ITEMS RECEIVED AFTER THE PRODUCTION OF THE REPORT
FOR THE PLANNING COMMITTEE
TO BE HELD ON 15 JANUARY 2015

LATE ITEMS FOR COMMITTEE

COMMITTEE DATE : 15 January 2015

Planning Application Ref:	2014/00242/FUL
Observations By:	Mr Lee M Howells
Date:	8 th January 2015
Location:	Land to the rear of St David's Primary School Colwinston
Proposal:	Development of 62 residential dwellings, open space, sustainable urban drainage, vehicular and pedestrian accesses, landscaping and related infrastructure and engineering works
Case Officer:	Mr. Robert Lankshear

Figure 1. The catchment area (black) draining to the site (red) based on a 1:25,000 scale base map.

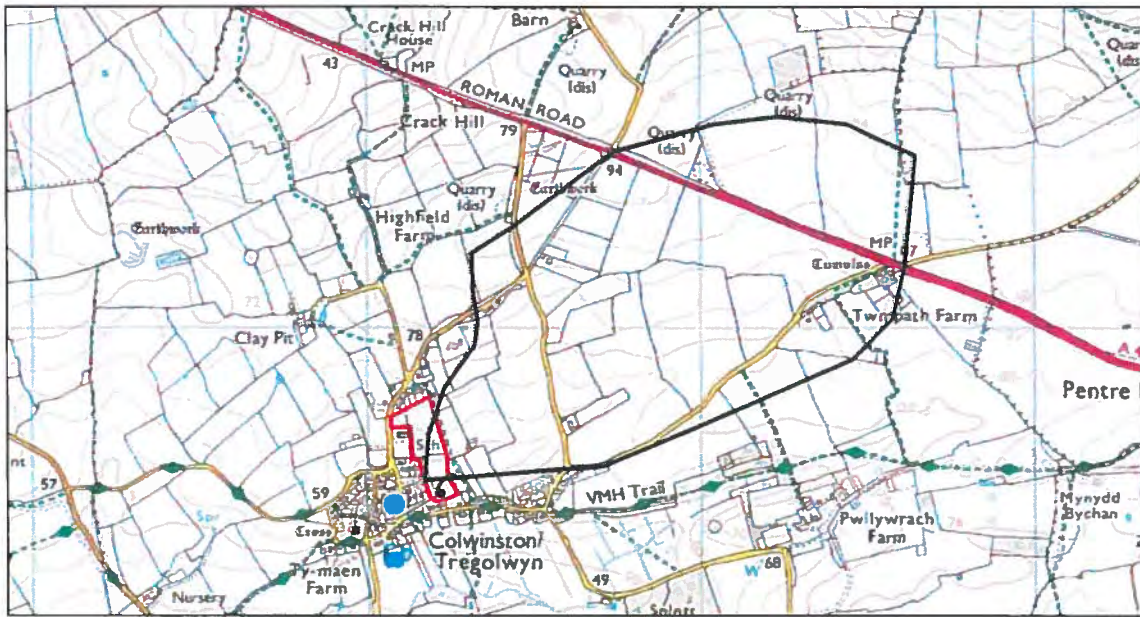
The revised report includes some information on the hydrology in that it identifies the area to be prone to surface water flooding and even provides an estimate of the catchment area as 73 ha (0.73 km²) is given. An initial inspection of the 1:25,000 map for the area would suggest a slightly larger area draining to the development site of 1.06 km² (Figure 1). Since no map of the catchment is presented in the revised drainage strategy nor the source of the information used to derive the catchment area, this value of 0.73 km² must be questioned.

Greenfield (pre-development) flows for different return periods are presented which have been estimated using the IH Report 124 methodology for the 0.73 km² catchment. This method is known to be a significant underestimate (Rodda, 2012) and different methods for the development site greenfield flows should have been used given that the area is moderately sloping and the IH 124 method does not consider the influence of slope (i.e. the flow from a steeply sloping catchment would be exactly the same as that from a gentle sloping catchment). Alternative estimates using the Flood Estimation Handbook (FEH – Institute of Hydrology 1999), which is the standard approved method for estimating floods in the UK, and the ADAS 345 method (ADAS, 1981), both of which include the influence of slope are given in Table 1 for the development site catchment. This supports the IH 124 method as a significant underestimate.

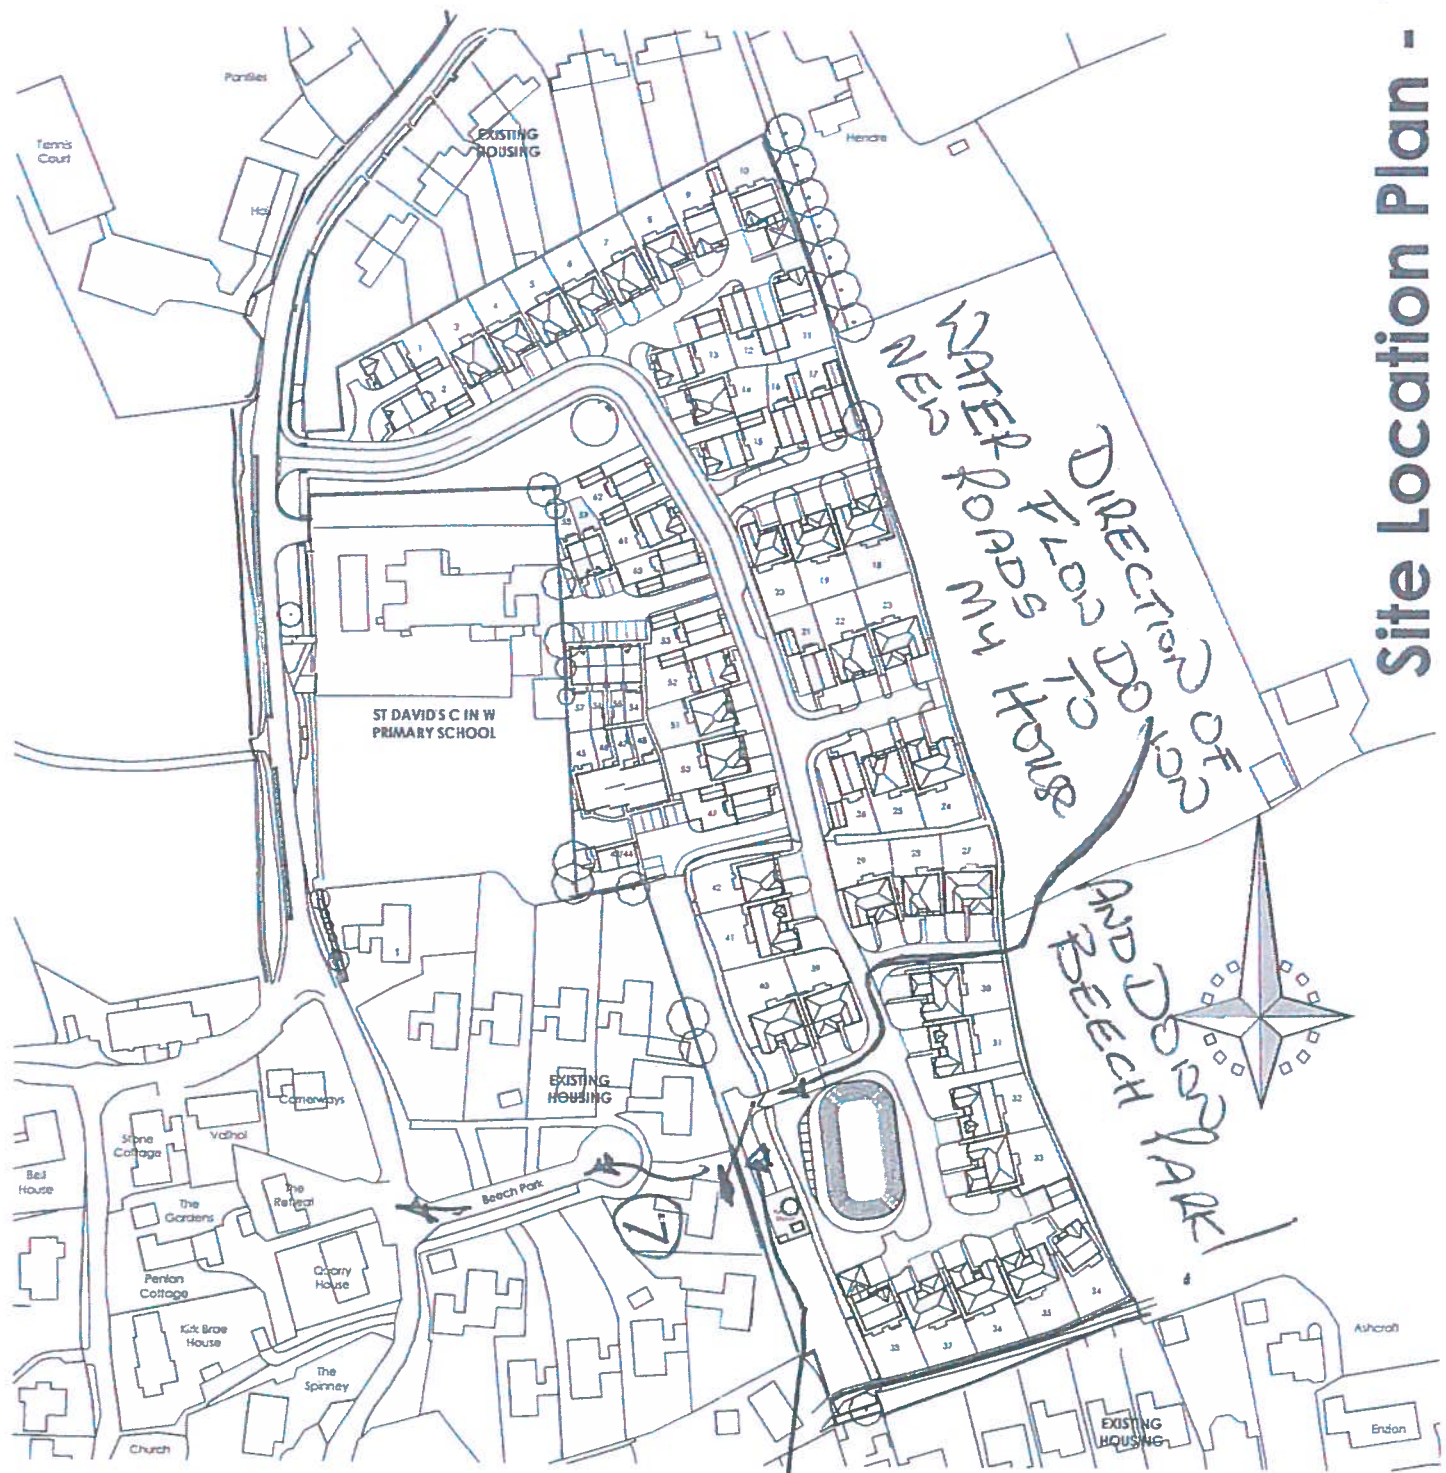
- a. Please refer to Drawing 1. There are some 300 + acres that act as the catchment area behind Beech Park from the Easterly entrance to the Village from the A48 to the top of Crack Hill, to Beech Park, along the Hen Cartref and back to the Easterly entrance. All surface water from this area converges to a point behind 7, Beech Park. At times of heavy rain and almost continuously during winter two sumps are formed behind the hedges of the two fields immediately adjacent to this property.

- b. Please refer to Drawing 2. There are some 70 + acres that act as a catchment area that lie between the top of Crack Hill, the fields to the West of Bakers Hill, Bakers Hill itself and down to the junction of Bakers Hill and Beech Park. There are no drains upwards of those shown in Drawing 1 on Bakers Hill. In flood conditions Bakers Hill flows as a river joining that coming down Beech Park outside Quarry House. The quantity of water coming down Bakers Hill by the same calculation as for a. is approx. 1.75 million gallons weighing 7,500 tonnes.
- c. Some 50 acres of land represents the catchment area covering the ground in the surround of Claypit Farm and below that drains across the Ewenny Road into the village at Bay Tree House (not shown on Drawing 2). This water goes both under
